Discuss and take appropriate action on Change Order #6 for Williamson County Regional Park.

RE: Williamson County Regional Park

Change Order #6

Williamson County Regional Park
3005 County Road 175
Court Fencing Locations- Basketball

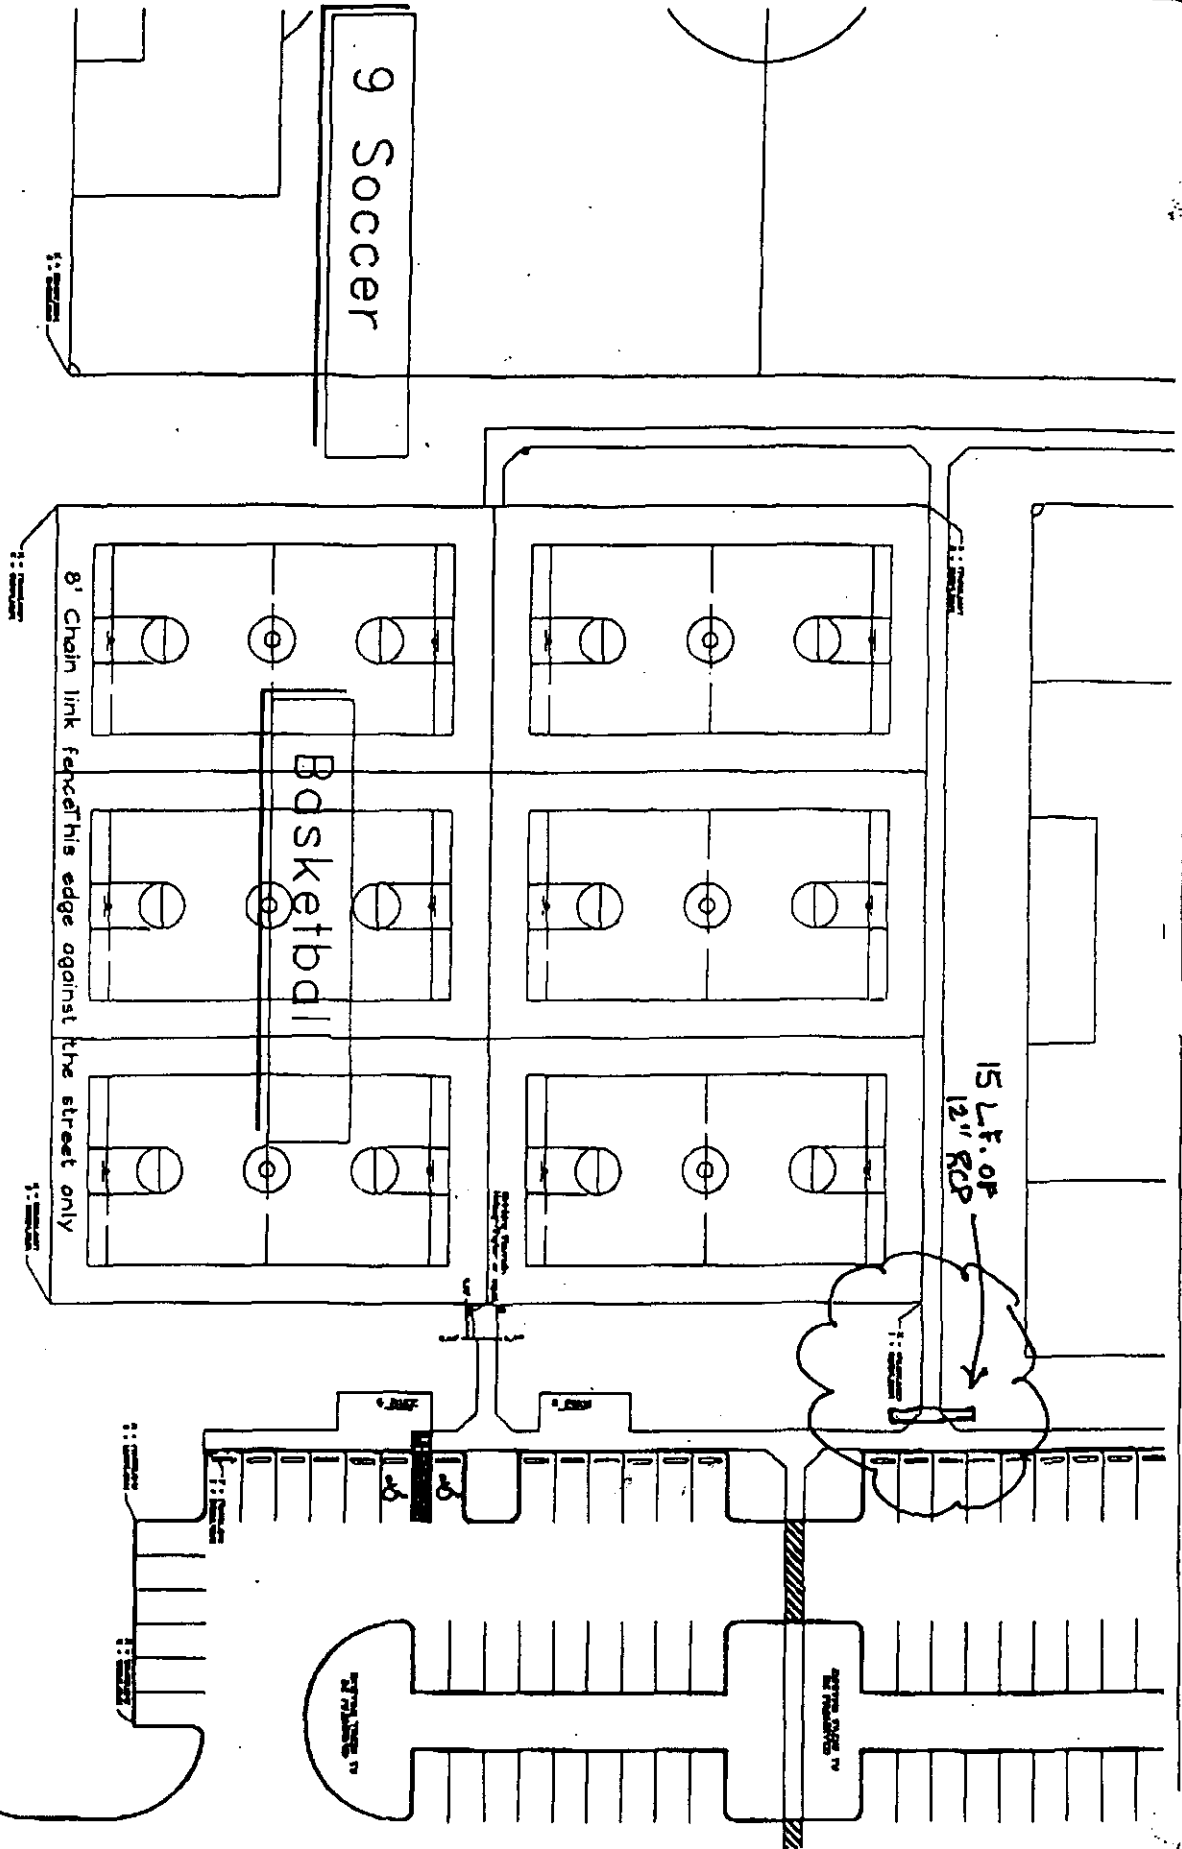
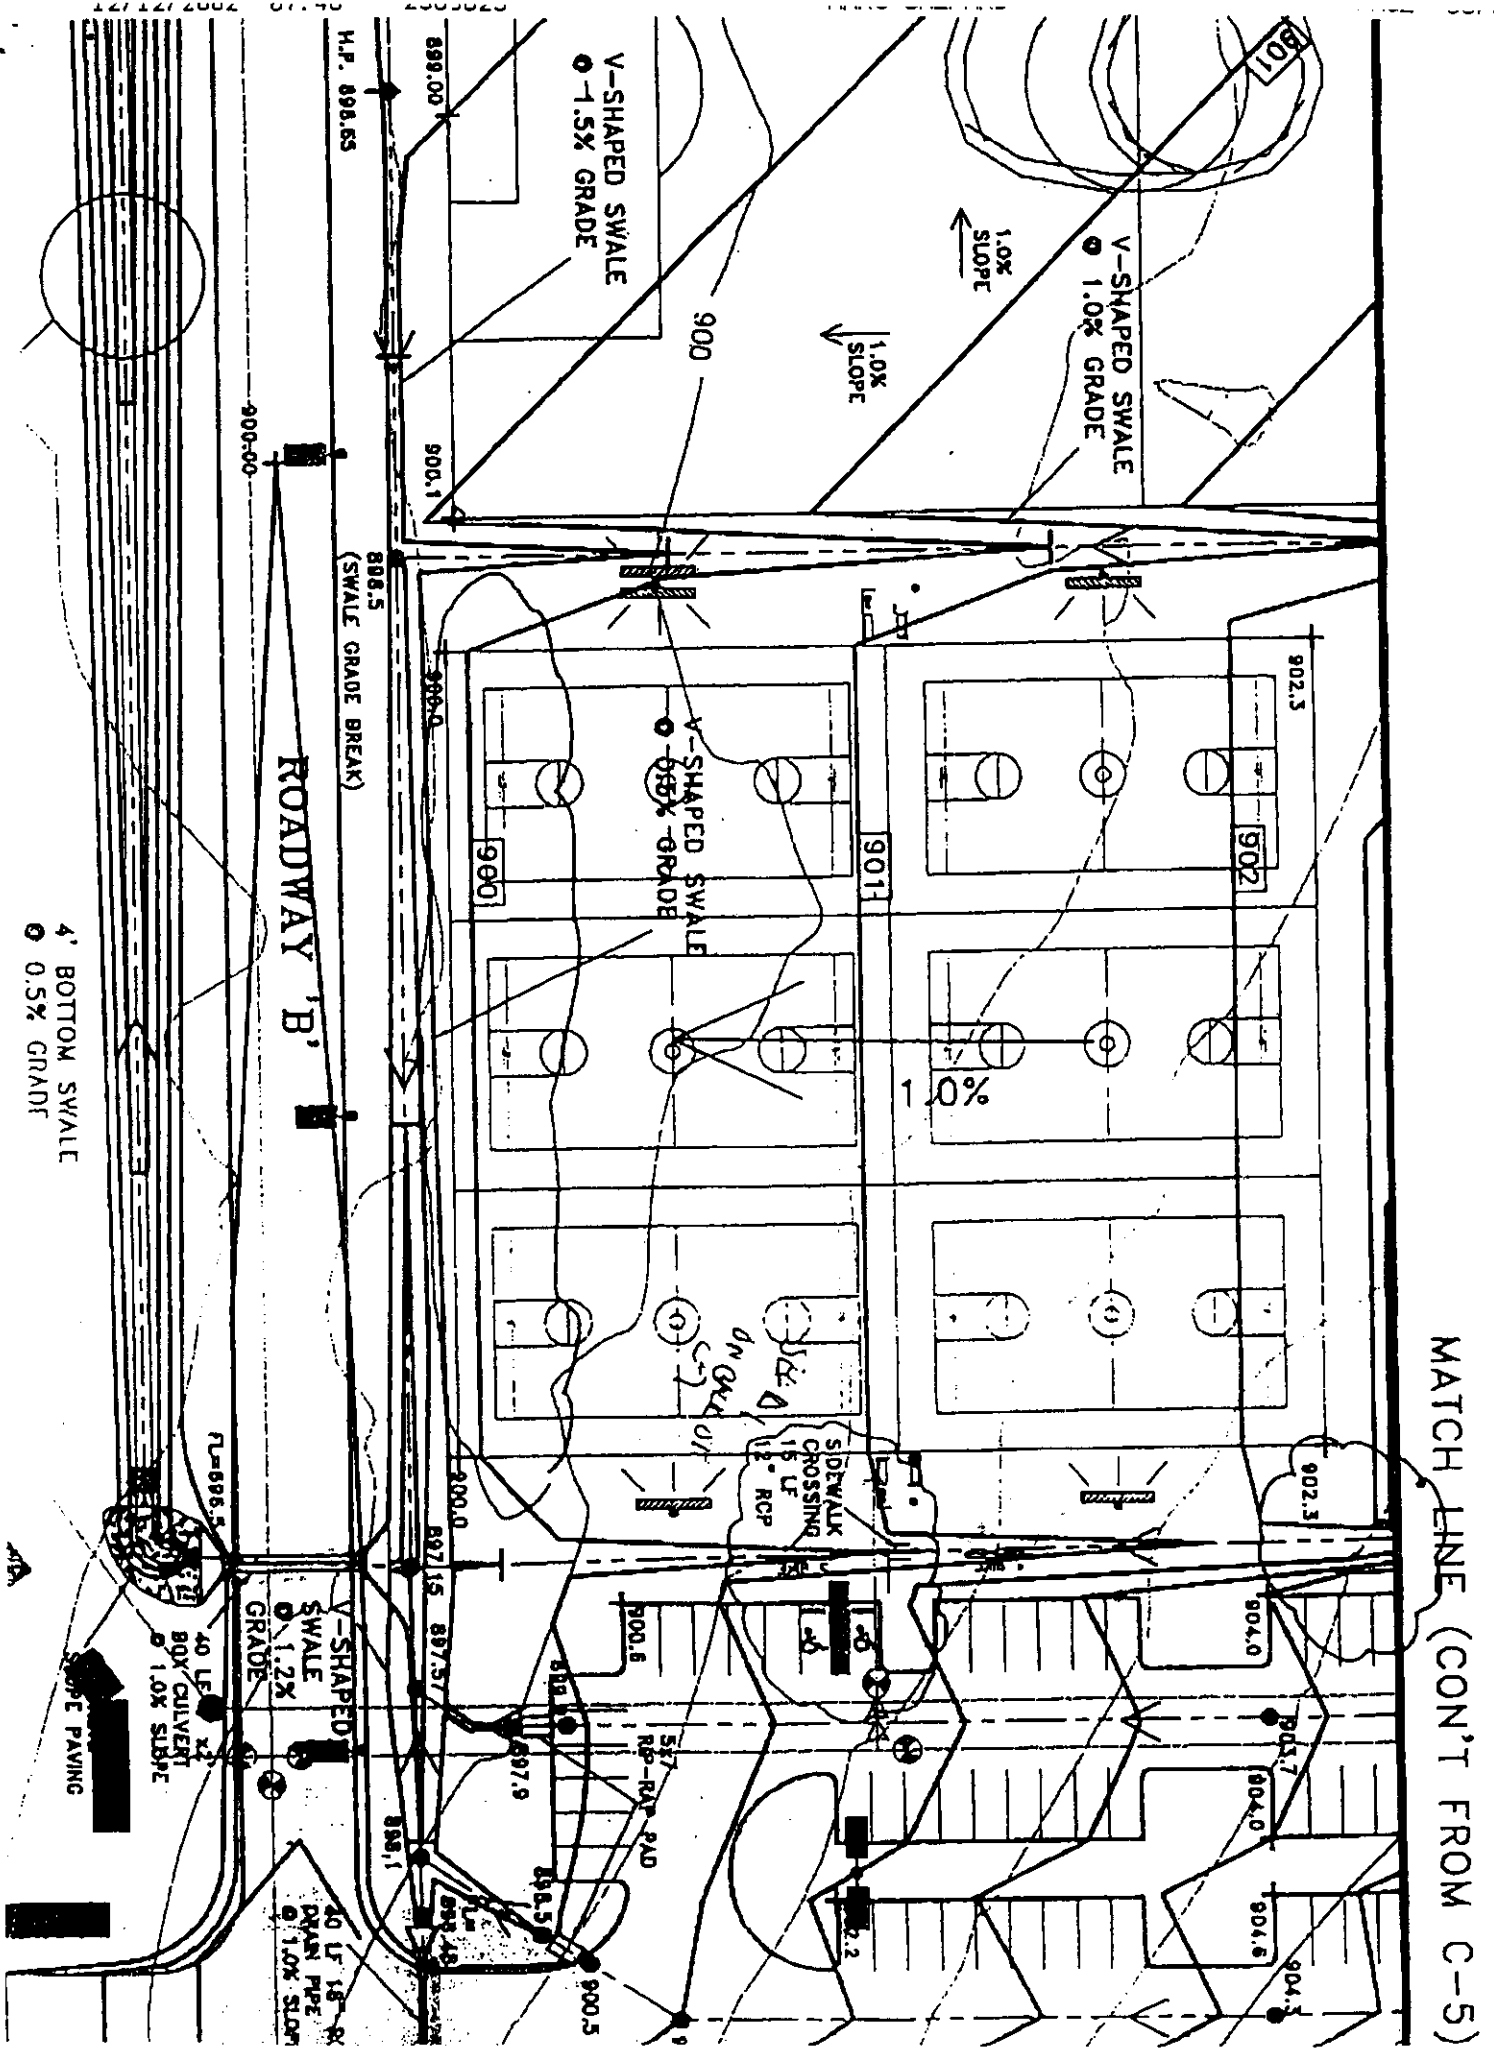
DESCRIPTION OF CHANGE: INSTALL 12" RCP PIPE FOR DRAINAGE UNDER DG TRAIL NEAR
BASKETBALL COURTS PER TRANSMITTAL No. 00552 DATED 12-10-02.

Re: LSI RFI No. 830
Storm Drainage for Commons Area
Williamson County Regional Park

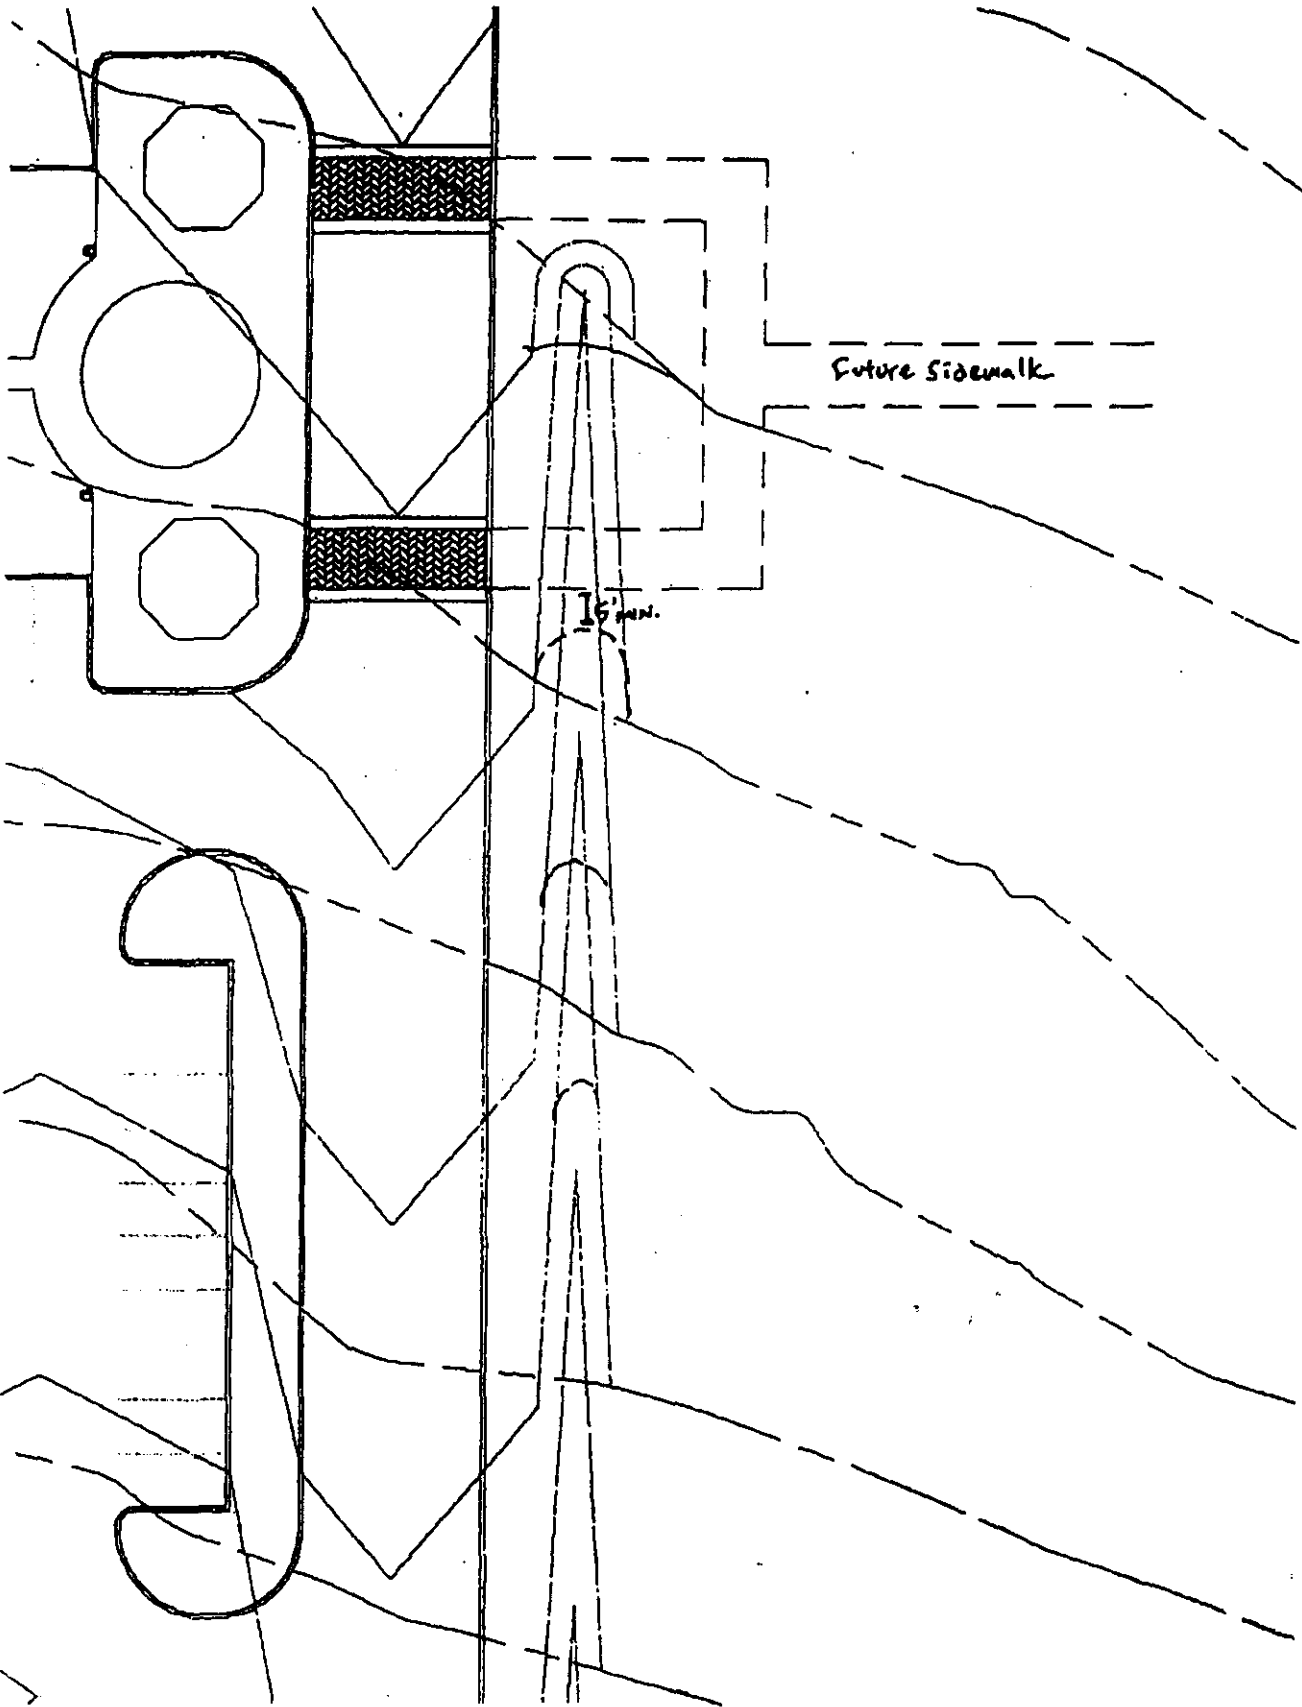
We have reviewed the proposed change in grading presented by LSI in a Fax dated November 7, 2002. The proposed change is to start the drainage channel on the inside of the Commons Area (west side) 5-feet south of the sidewalk crossing area. This change will not affect the area drainage significantly and can be done. However, it should be noted that sheet-flow drainage from the commons area may start to be concentrated near the point where the sidewalks will cross the roadway. When this occurs, the flows will erode any decomposed granite trail that may be constructed. Since this sidewalk will not be installed as part of this phase of construction, the drainage pattern may be observed from the Commons Area and if concentrated flows are observed, then the drainage swale may need to be extended further north to collect this flow. A culvert pipe could then be installed for the section where the sidewalk crosses the drainage swale if surface flows over the sidewalk are not desired.
